66311B-07

S E R V I C E N O T E

Agilent 66311B DC Power Supply

On faster computers, when programming over GPIB, a random error will occur.

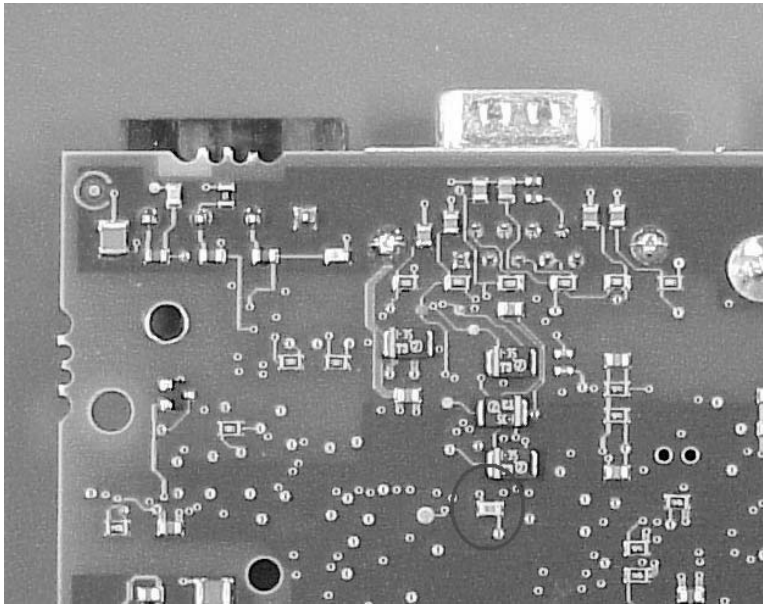
When programming a unit over GPIB, a random error -113 (“Undefined header”) will appear on the unit. This error can be read back via the front panel or over the GPIB bus.

Change resistor R1246 (see picture for location) from 511 Ohms to 100 Ohms (part number 0699-3058). This requires soldering a surface mount component and can be very difficult. This does not require re-calibration.

Replace the entire GPIB assembly (part number 5063-4841) with a newer one that has the 100 Ohm resistor. This will require the unit to be re-calibrated.
